MILLENIUM PARC REPLAT #2

Updated: October 21, 2014

MILLENNIUM PARC REPLAT TWO A REPLAT OF MILLENNIUM PARC REPLAT ONE, RECORDED IN PLAT BOOK 65, PAGES 115-116, PUBLIC RECORDS OF ORANGE COUNTY, FLORIDA

PROPOSED PLAT

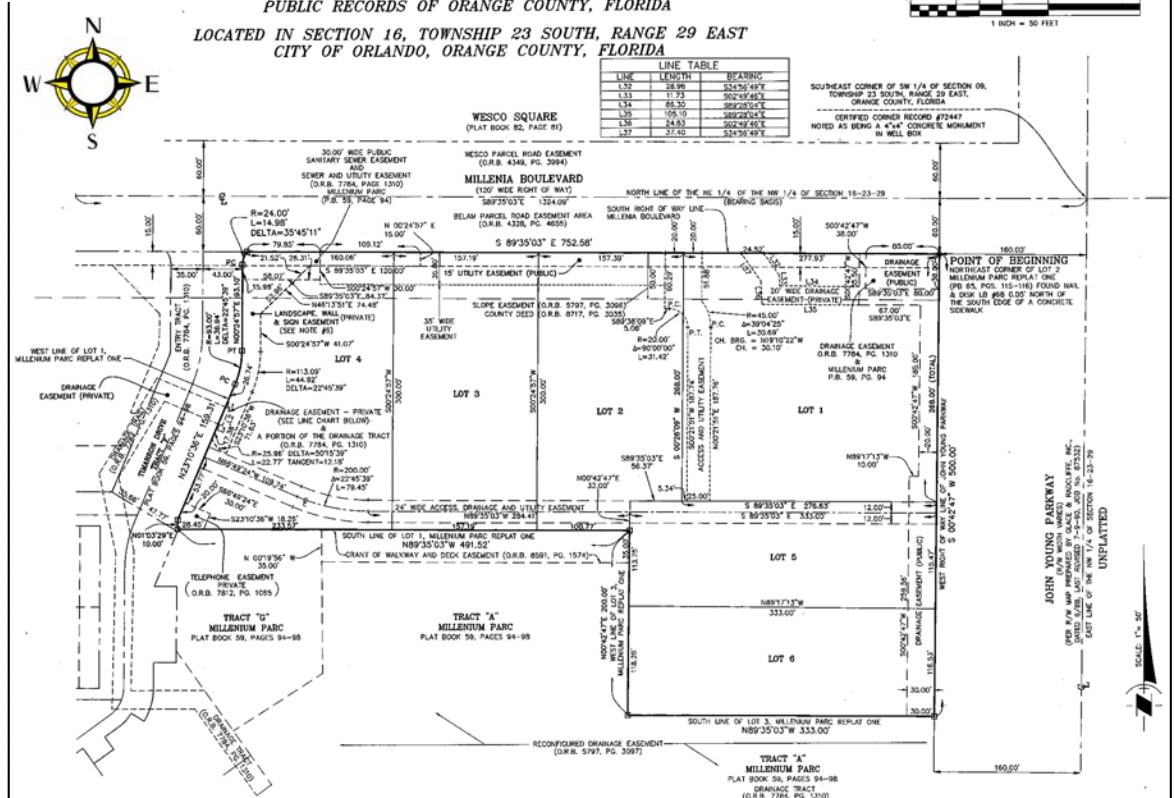
City Addressing - Please correct the following: Change "JOHN YOUNG PARKWAY" to "S JOHN YOUNG PARKWAY" (no period after the S).
